# Addendum Number 1

June 26, 2020

USC Library Annex – Implement Exterior Repairs

Owner Project Number: FP00000324

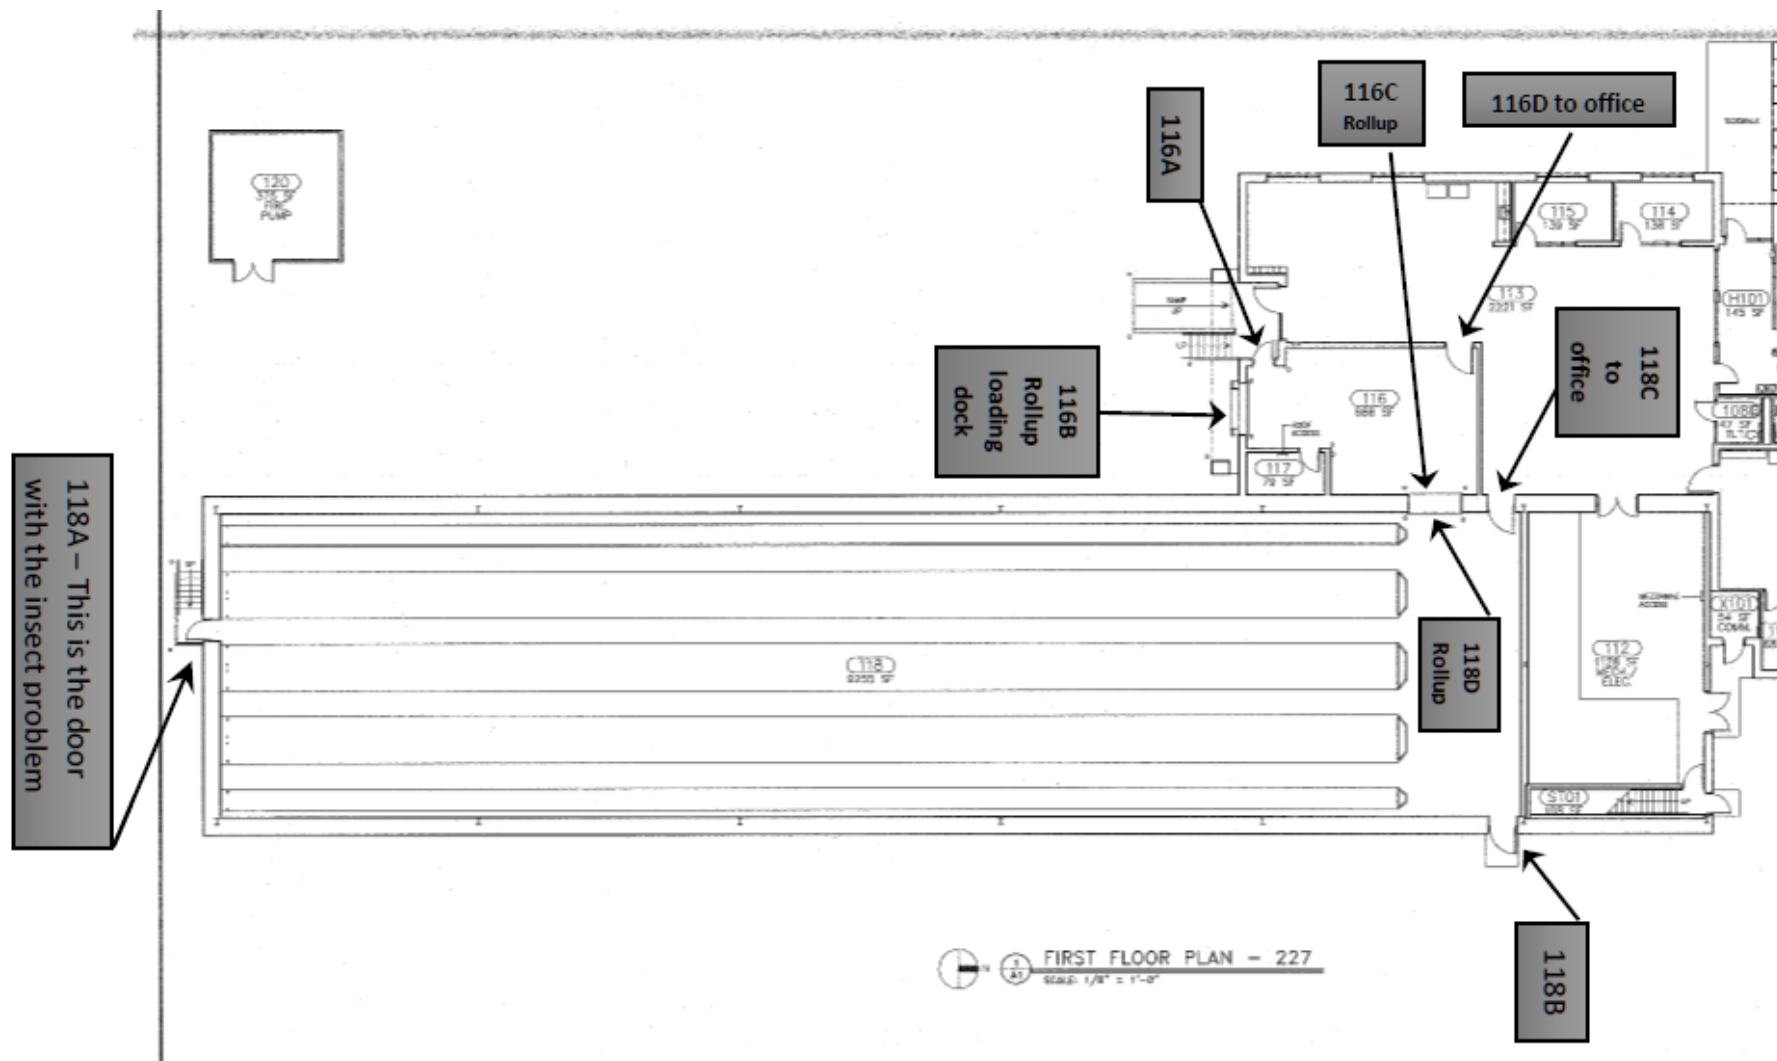
**Changes to Contracting Requirements:**

- a. See attached map.

118A - panic bar inside/ Mortise lock outside

118B - panic bar inside/ Mortise lock outside

118C – interior automatic door no locks.

116A – panic bar inside/ Mortise lock outside

116D – interior automatic door no locks.

W102 (REVISED)

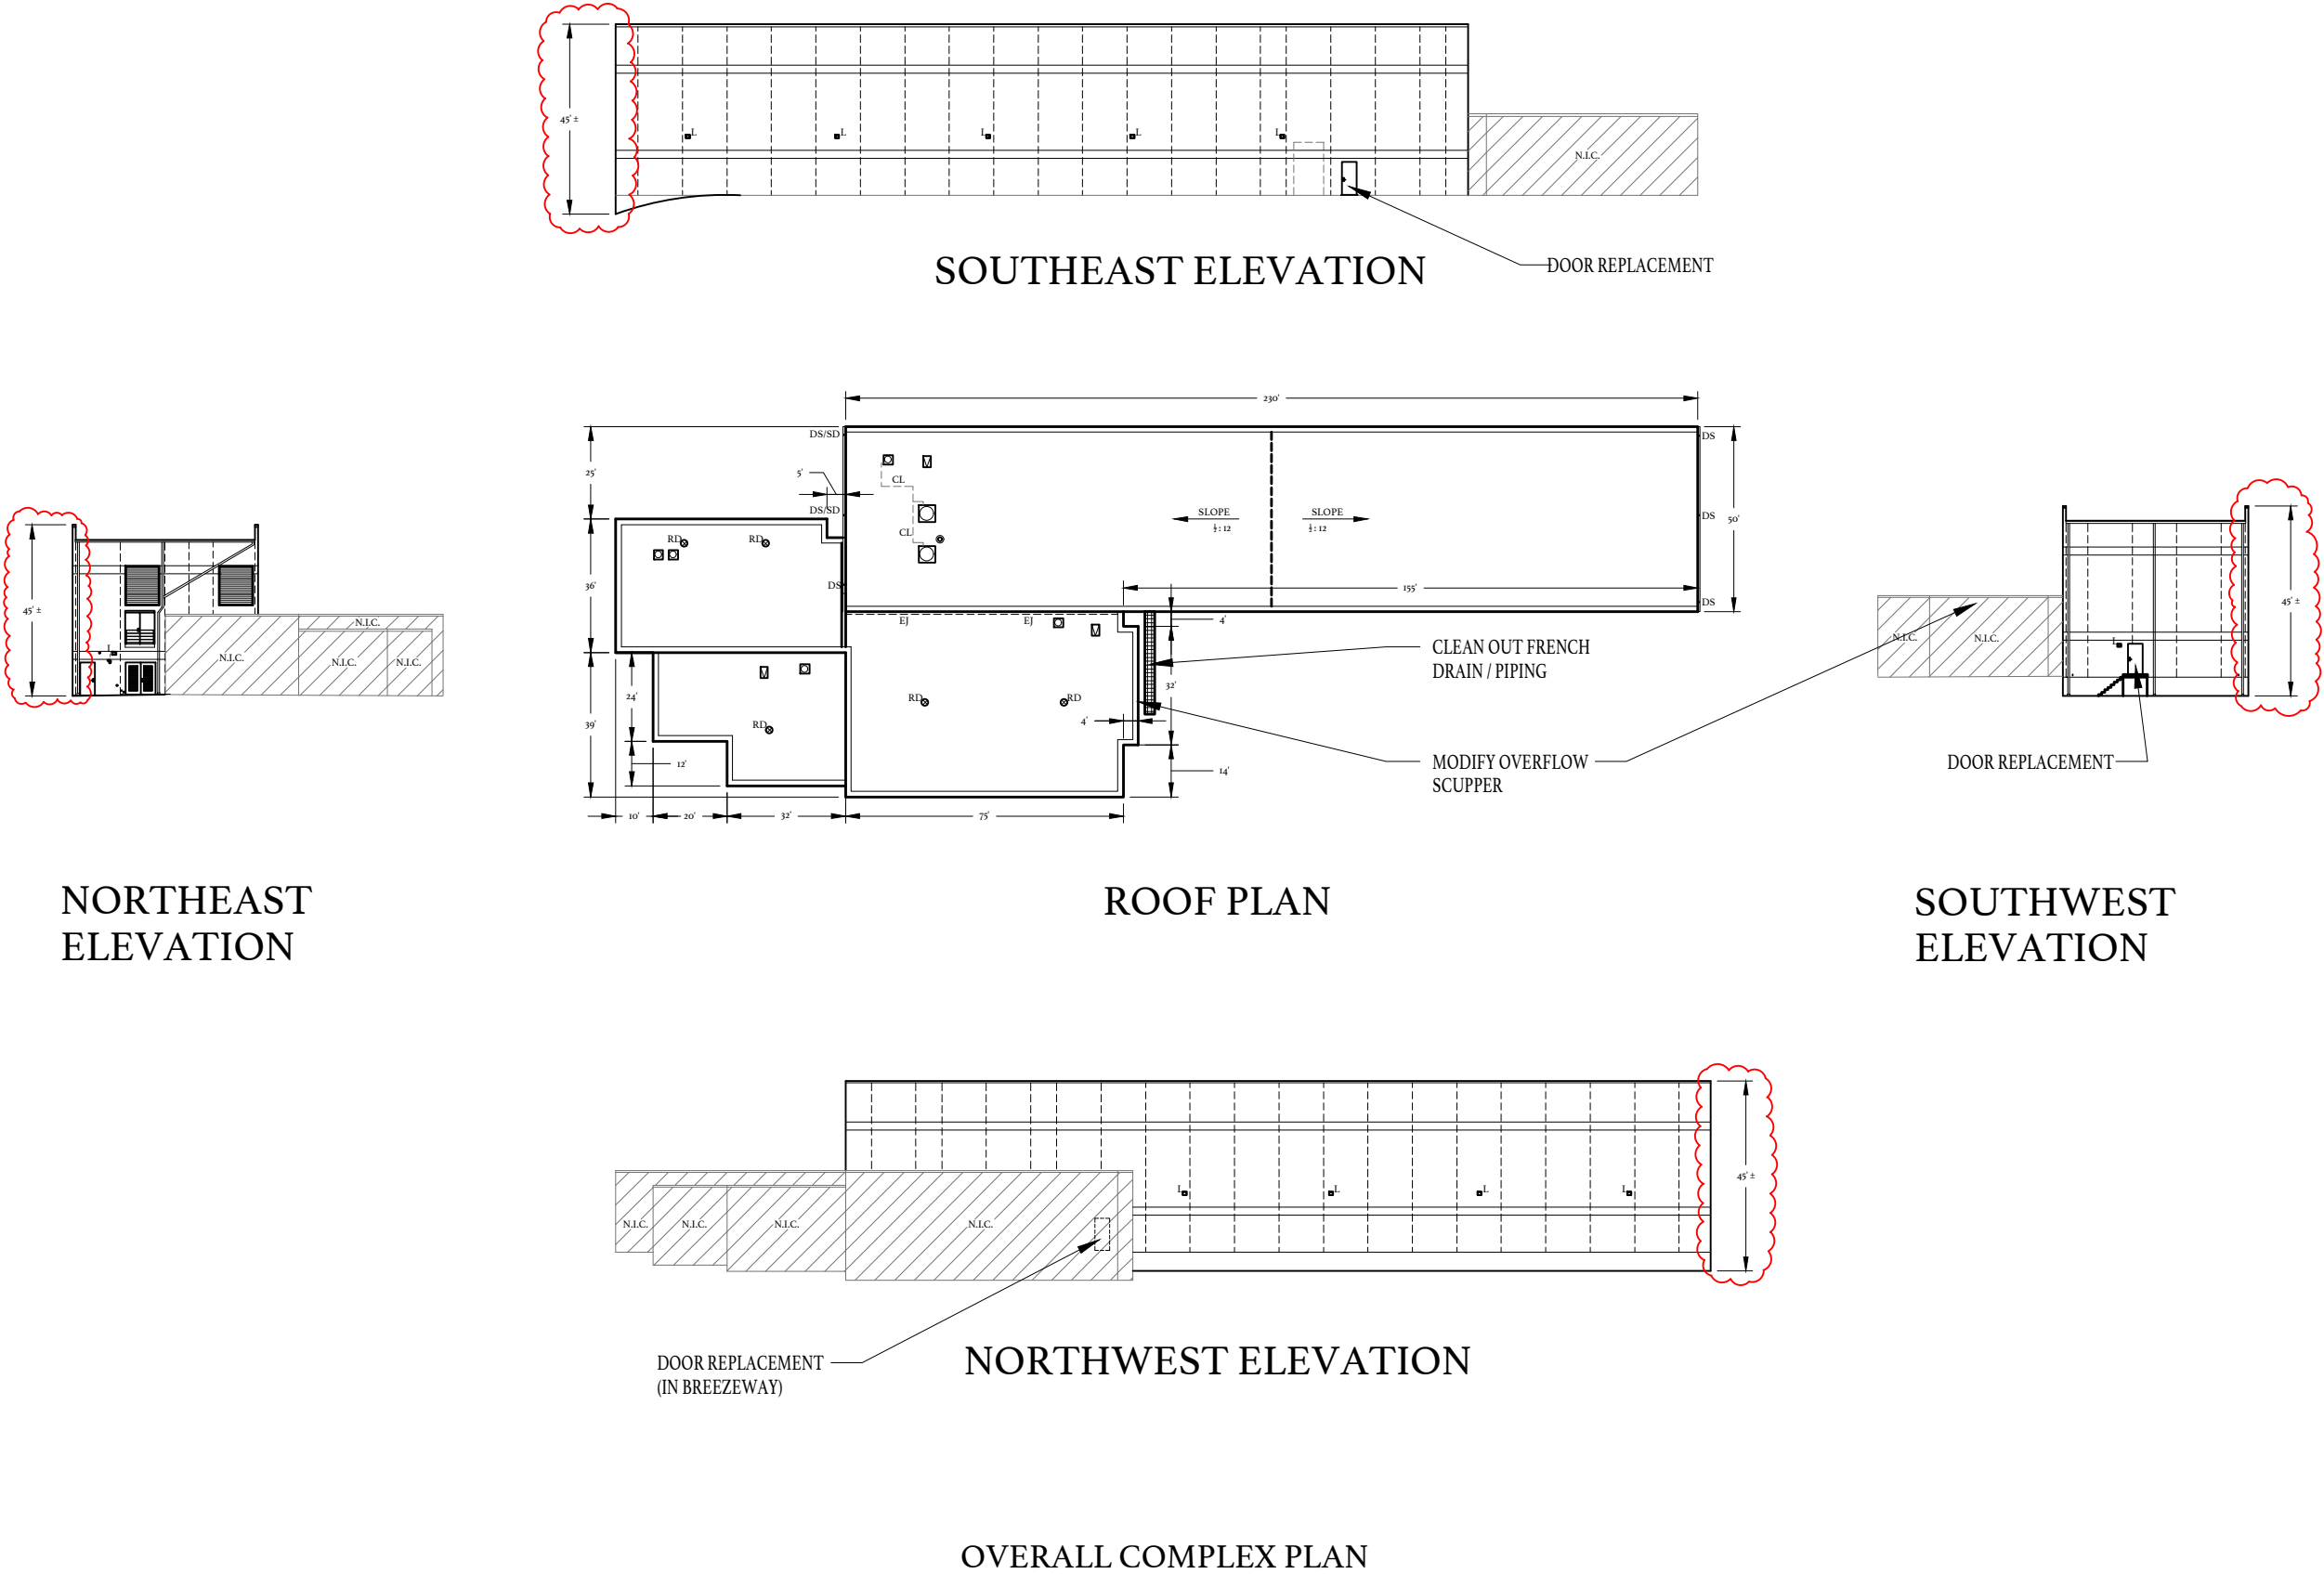
12. Sheet W101, General Notes, Scope of Work, D.:
  - a. Change to read: "Alternate Number 1 work includes complete removal and replacement of three insulated steel doors including all new hardware, weatherstripping and seals. One of the three existing doors is currently steel door with glass to be replaced with solid steel door.'
13. Sheet W102, Overall Complex Plan:
  - a. Replace with the revised, attached Sheet W102, Overall Complex Plan.
14. See the attached site plan for laydown/storage/access area(s).

- a. See Addendum Number 1, Revised Sheet W102.
